TRANSMITTAL

Project Description: Replacement Senior Citizen Center Construction

To: Josh Marrillia, Marrillia Design & Construction RE: Change Order #27 – Fully Executed

**LEXINGTON-FAYETTE URBAN COUNTY
GOVERNMENT CONTRACT CHANGE ORDER**
Page 1 of 2

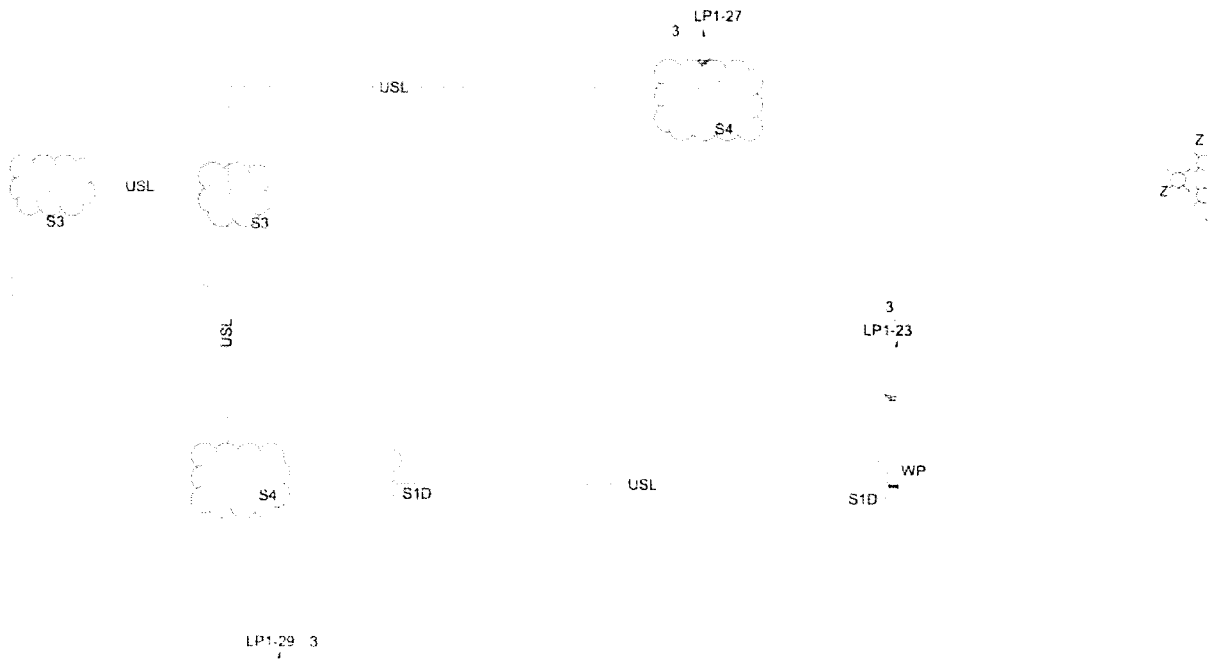
AES's pricing above concerns the modifications to the already placed conduits to move these lights out of the parking lot modification stone. The head that is in the light in the sidewalk will be as previously scheduled.

ASI Transmittal

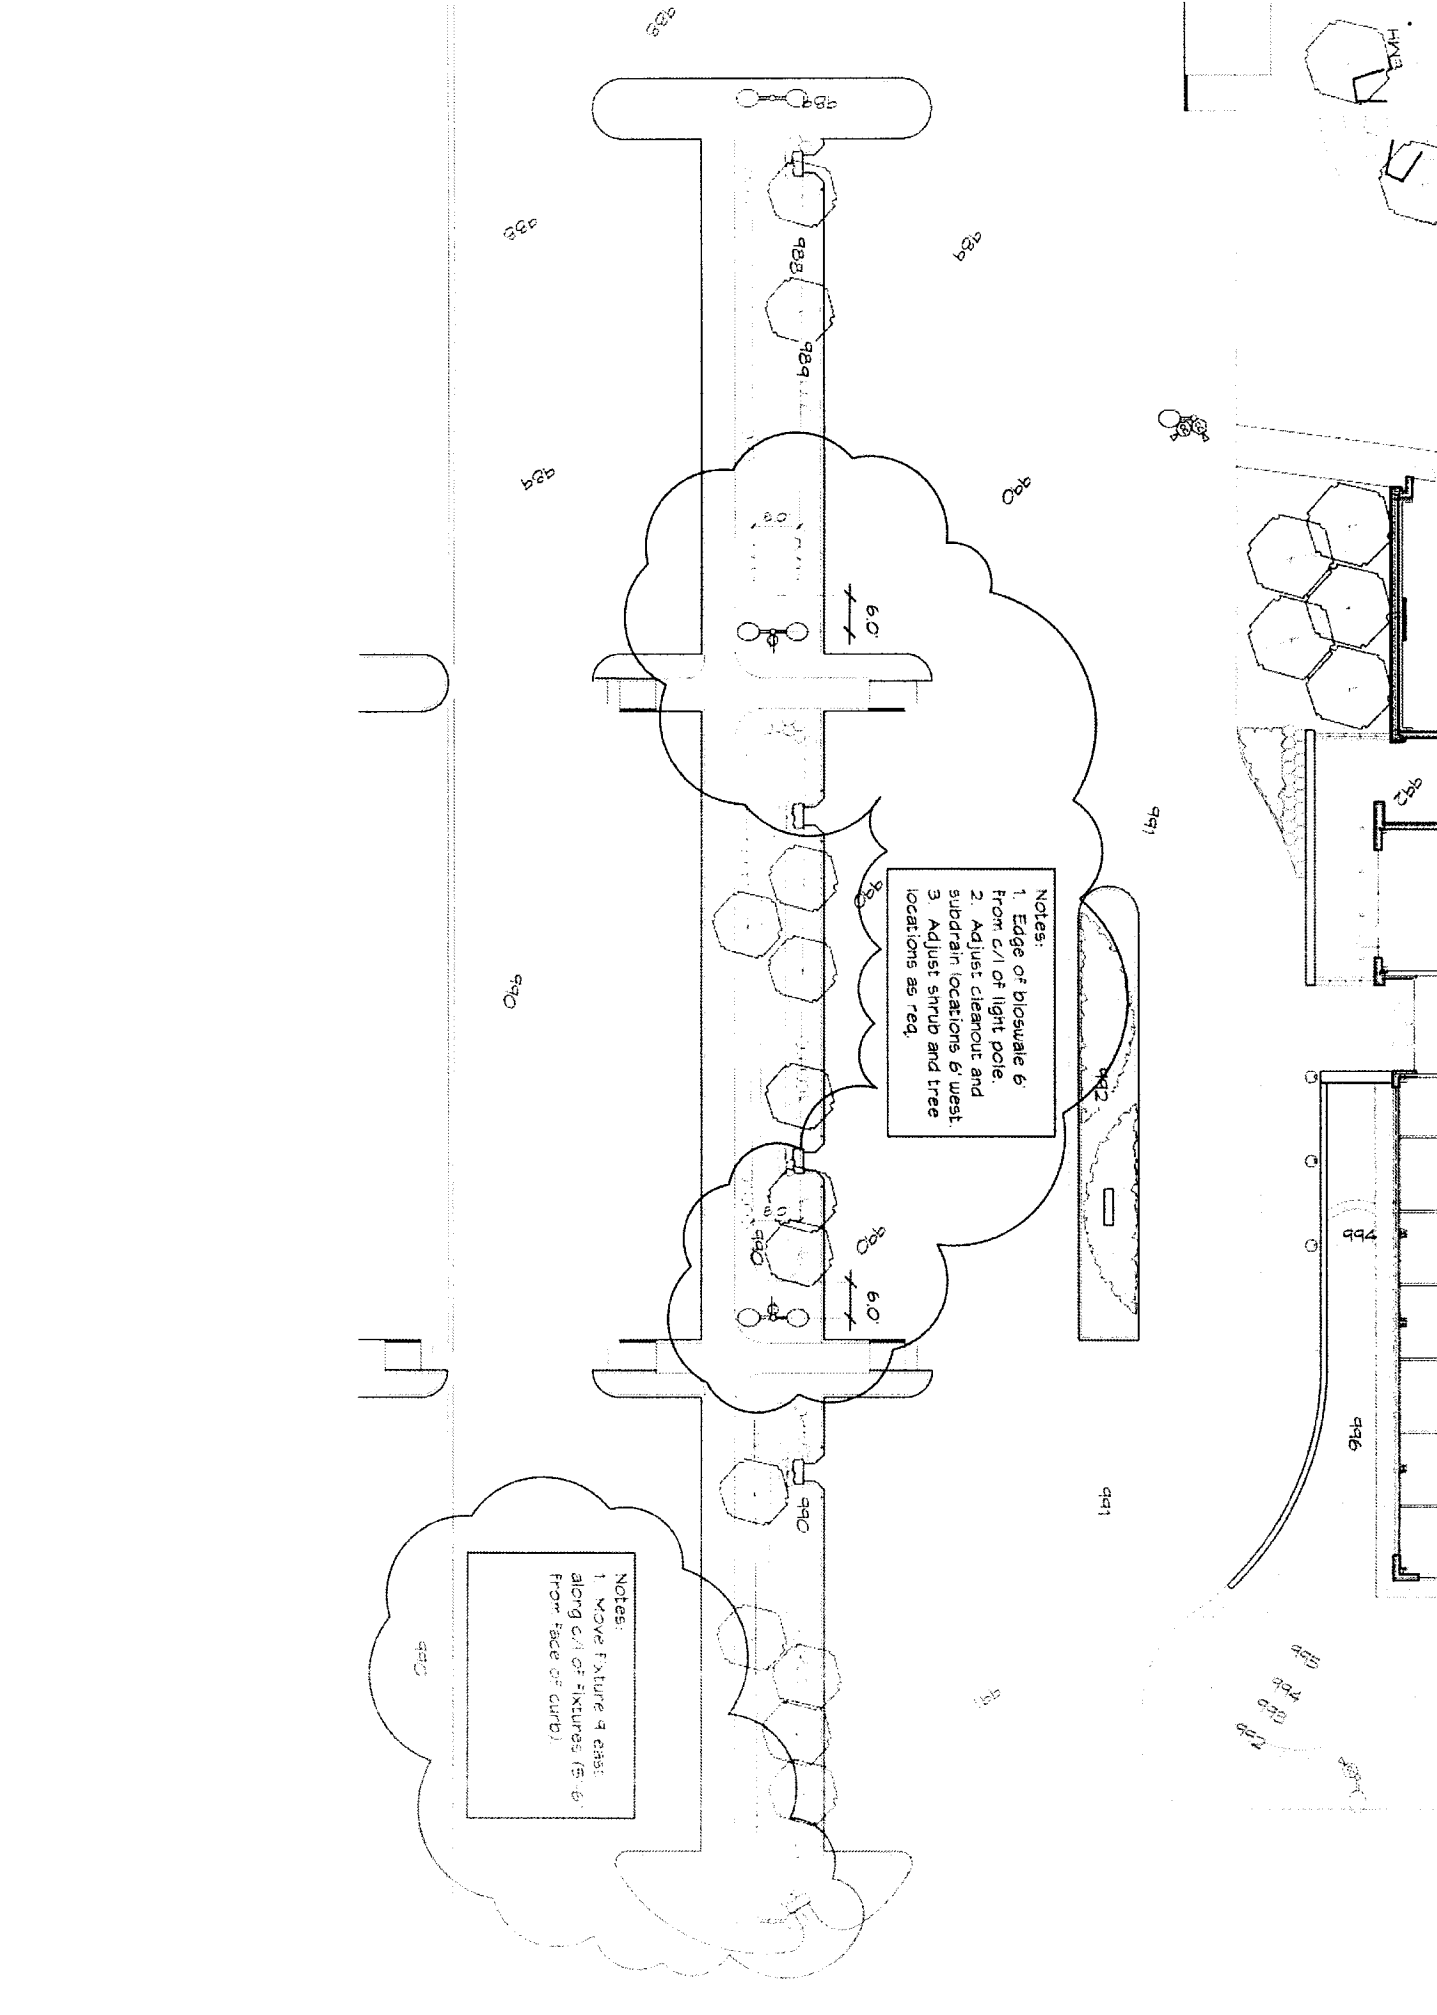
Two clarifications on pole light locations. The first covers an item we discussed earlier, the bioswale pole lights. I have attached the sketch by Element Design for the record of pole light locations in the bioswale. The second concerns perimeter pole lights. Per our discussion on site this morning, the centerline of pole lights shall be 18" back from the stake placed to mark curb/gutter locations. This will place the centerline of pole lights 48" from the back of curb, and provides at least 9" of separation between parking lot undercut in the field (which appears to be 18-36" beyond back-of-curb in the field). East-west locations of pole lights shall remain as drawn.

At the north bank of accessible parking spots, there is one pole light shown in the sidewalk. This will be moved north of the sidewalk, to be positioned 18" from the north edge of the east-west sidewalk, and 18" EAST/WEST of the north-south sidewalk. The head on this pole light will need to be changed to model #

RFI-110/111- PLAN

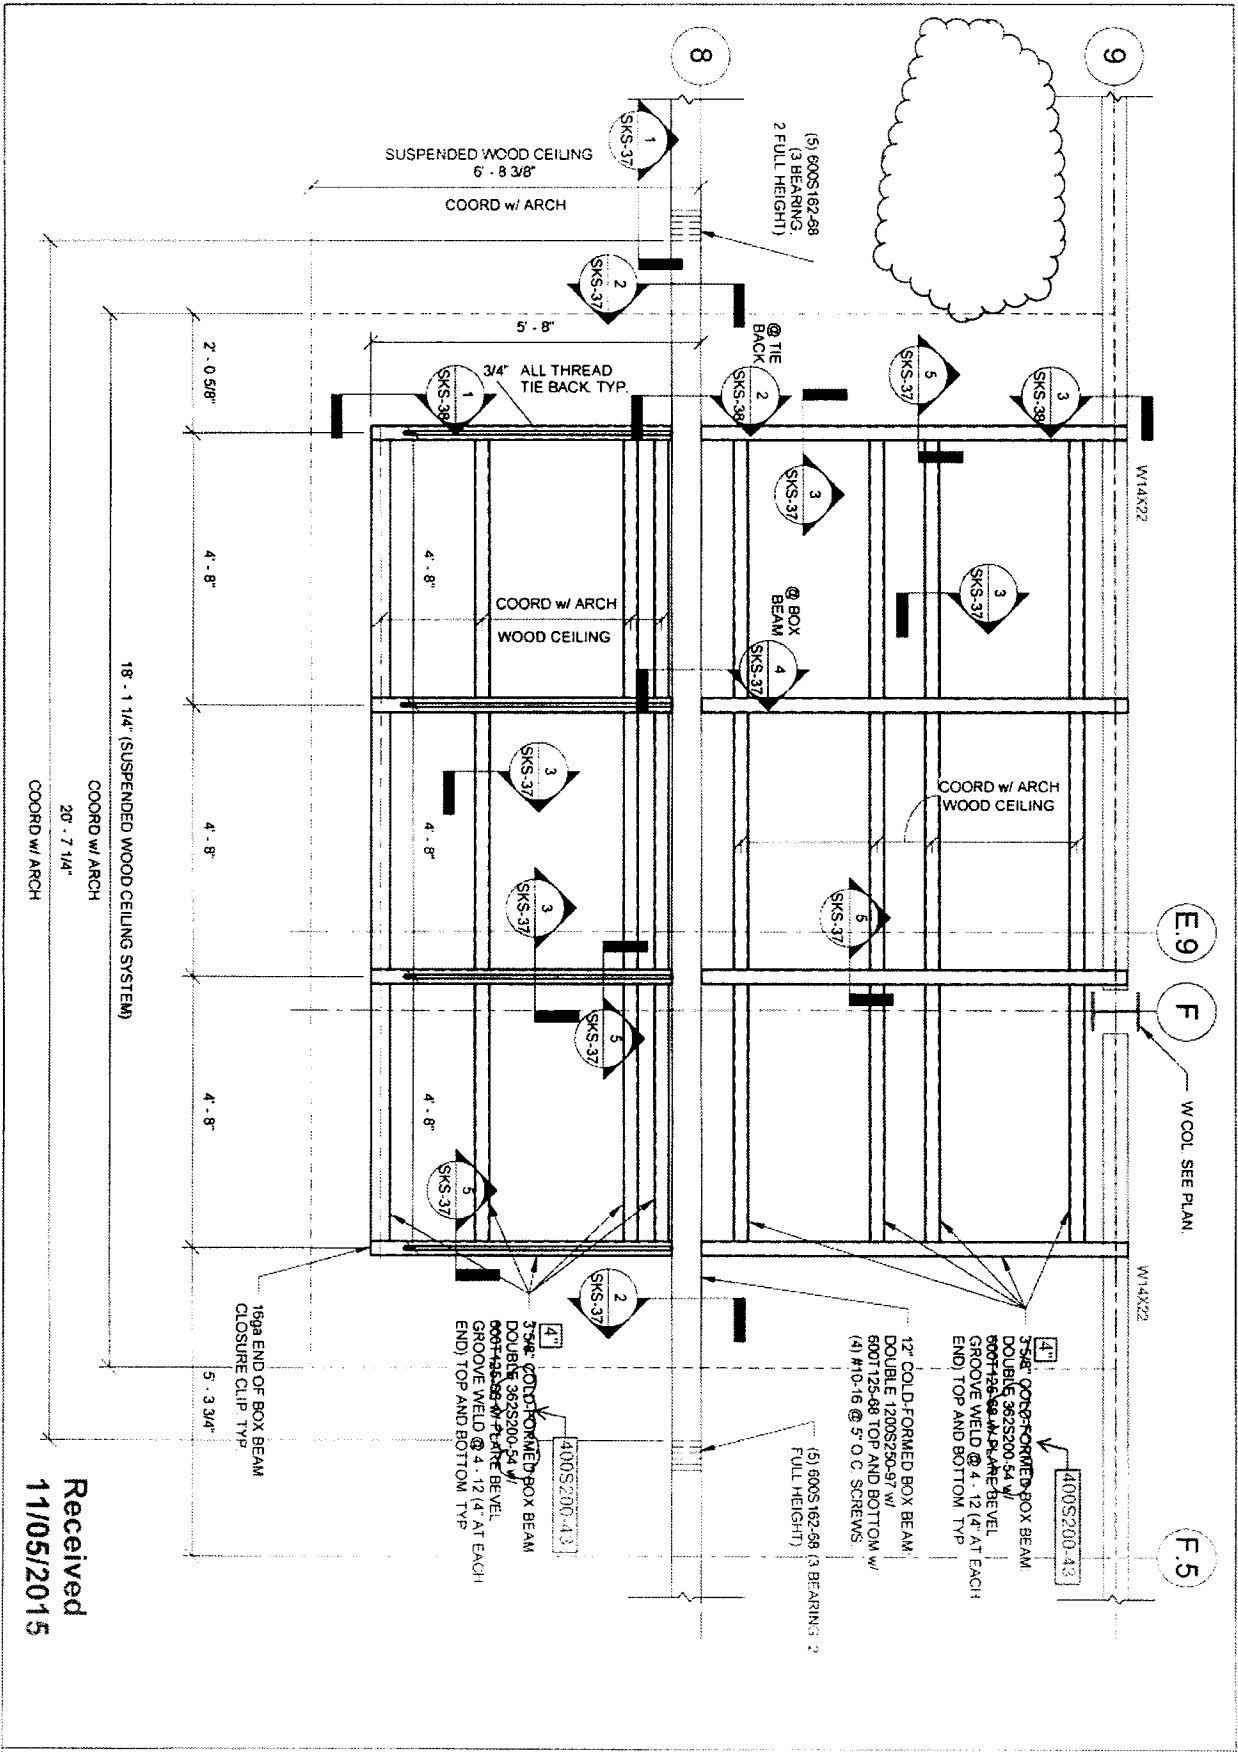
Please provide pricing to revise the construction of the platform canopy framing from HSS steel sections to light gauge steel framing. Coordinate with adjacent framing and related fixtures and finishes.
